**Case 22254  
Site Plan Approval:  
5640 Sackville Street  
and 1577 South Park  
Street, Halifax  
Design Review Committee**

March 25, 2019

Proposal: Modify  
existing site plan  
approvals to change  
roof line, windows and  
louvres on the eastern  
elevation, changes to  
the Sackville St  
elevation and addition  
of an architectural  
treatment on the 7<sup>th</sup>  
floor of the Pavilion  
Building

## North Elevation Revised Request

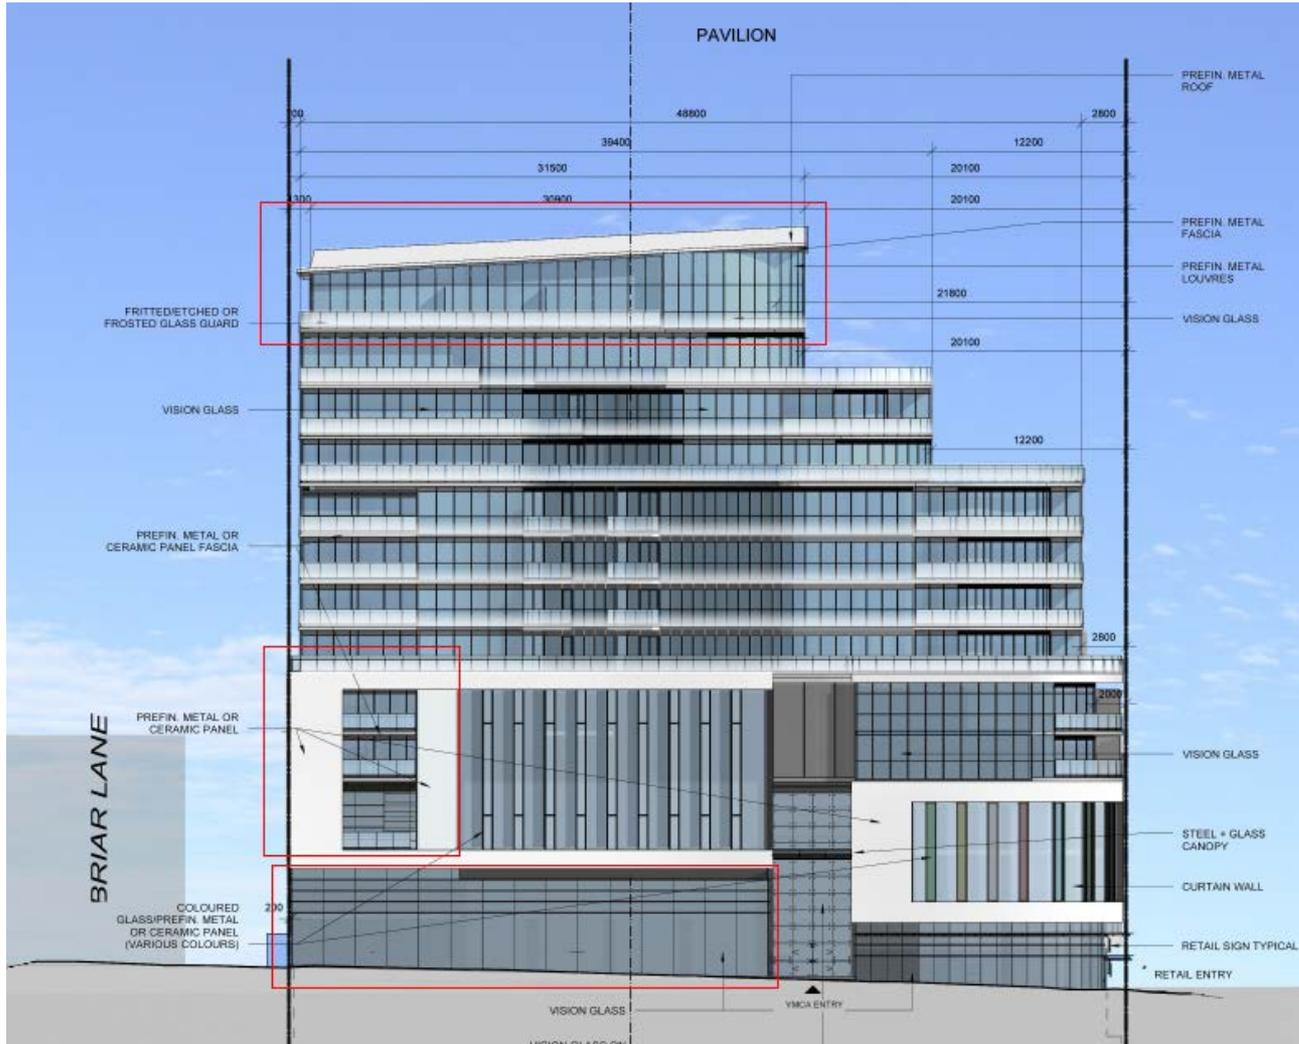
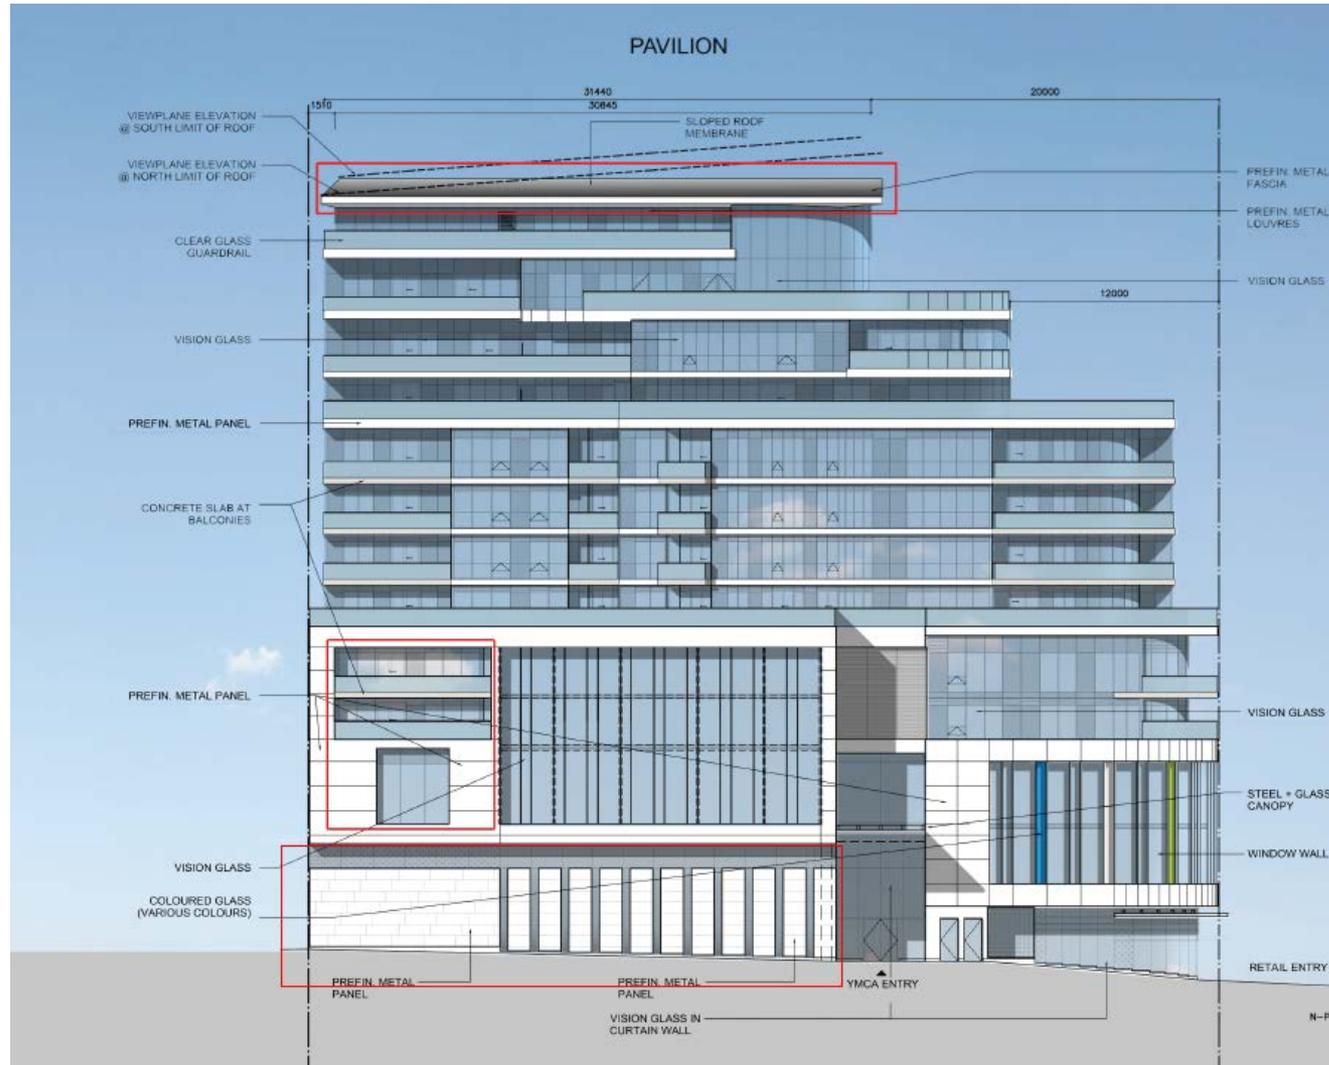
- Prominent roof line
- Sackville frontage is 100% glazing

- Proposed change reduced to 19% glazing
- Angle of roofline changed
- Terrace changed
- Windows extended and balconies added
